## GM 6L80/6L90

### PUMP ASSEMBLY INTERCHANGEABILITY

Figure 1

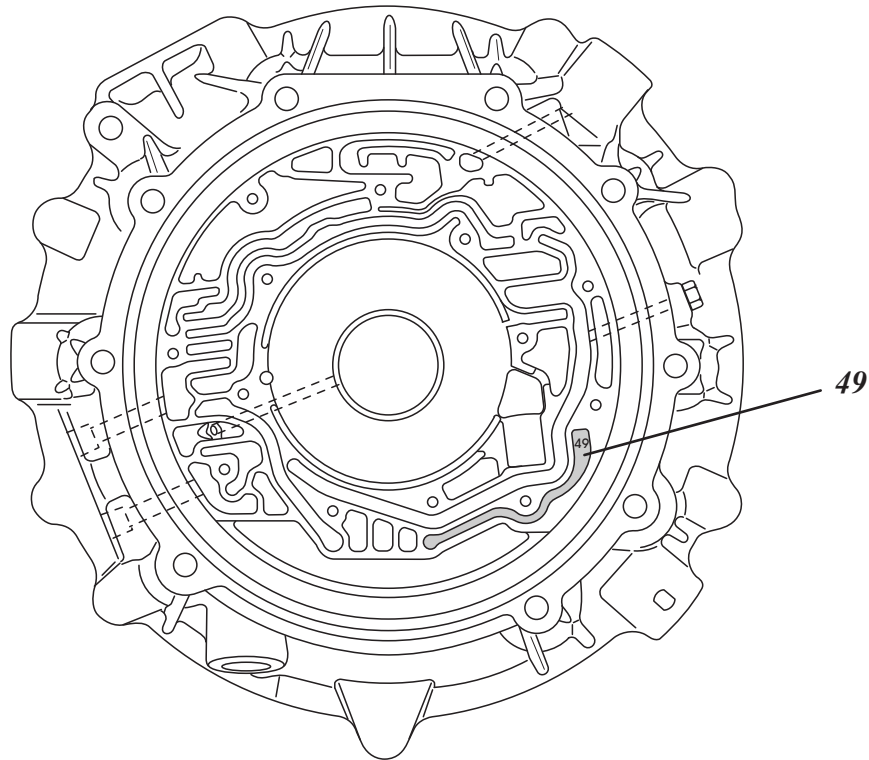
The oil passage in question services hydraulic circuit 49 which is controlling the pressure from the pressure control solenoid to the pressure regulator boost valve as seen in Figure 1.

Figure 2

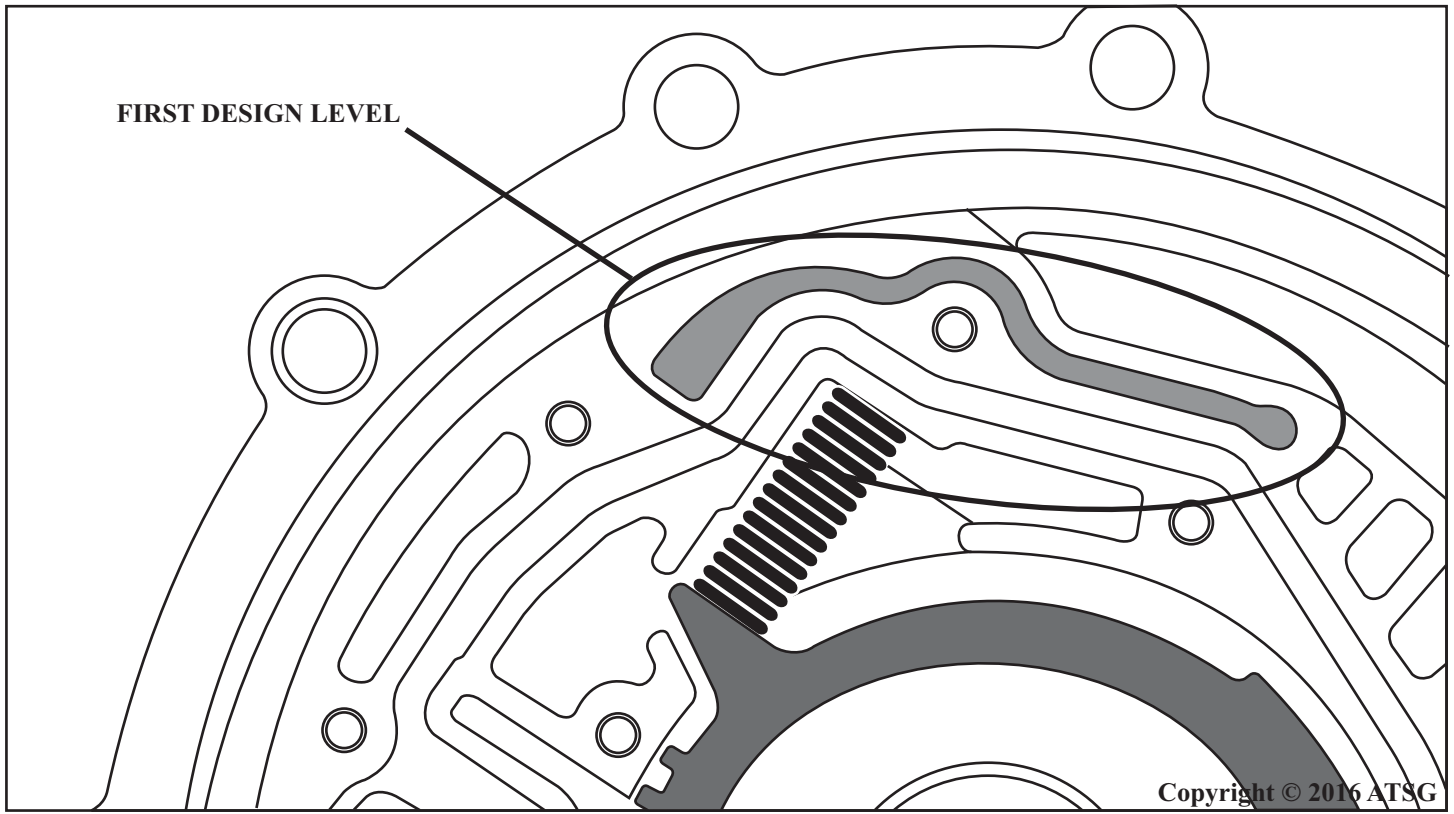
Circuit 49 in the first design pump assembly originates from the pressure control solenoid (Figure 2). It comes into the pump cover, then to the bellhousing and ends at the bolt hole. It then goes back to the pump cover and around the bolt hole then back into the bellhousing to the very end of the circuit where it goes back into the pump cover to the pressure regulator boost valve.

**CORRECTION:** Both pump assemblies are totally interchangeable. The first design was in production from 2007 to 2008. The second design was put into production in 2009 and is still currently used.

Figure 3

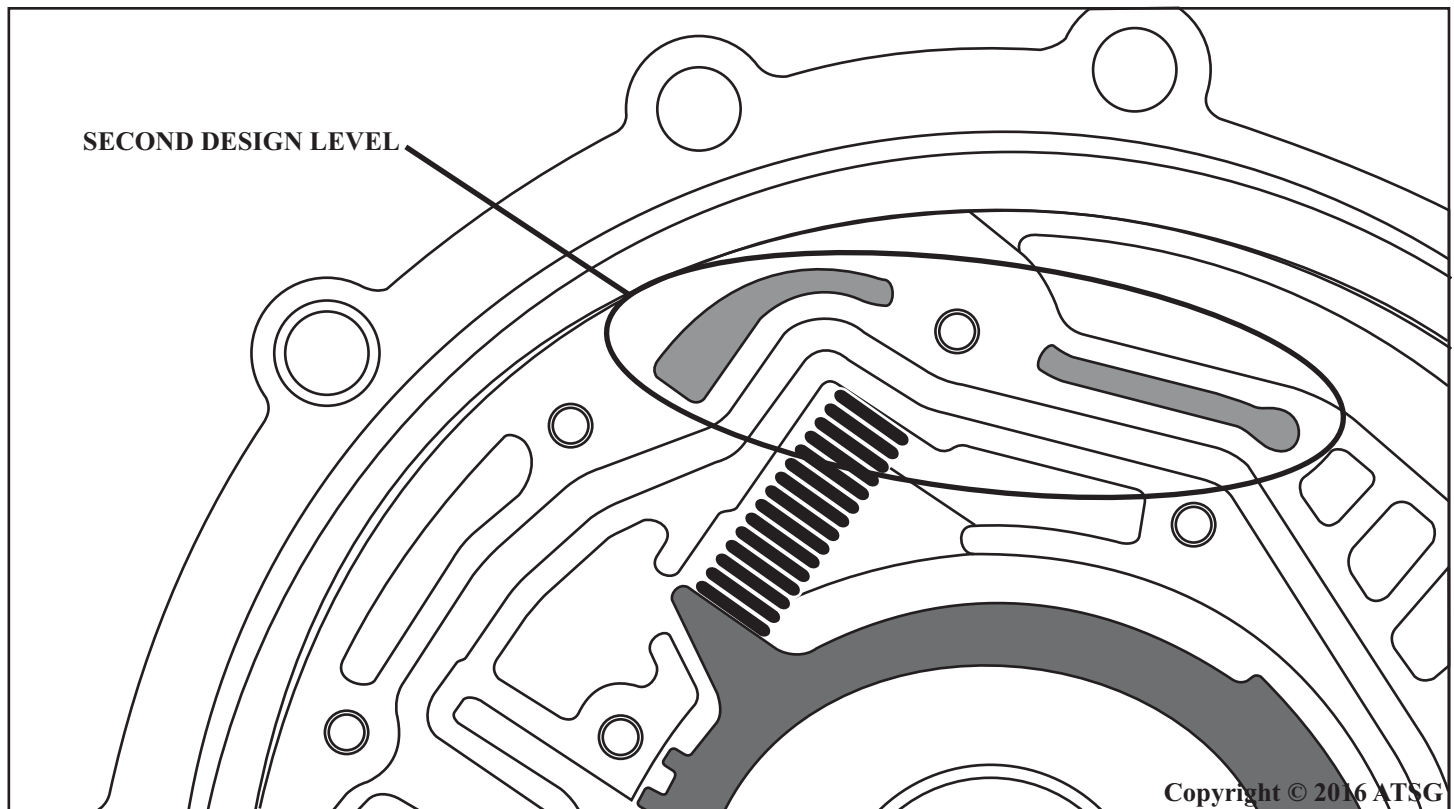
Circuit 49 in the second design pump assembly has a dam in the circuit (Figure 3). It appears to be there to orifice the oil from the pressure control solenoid to the pressure regulator boost valve. However, there is no information available from GM that explains exactly why the change was implemented. The pump cover for both first and second design levels can be seen in figure 4.
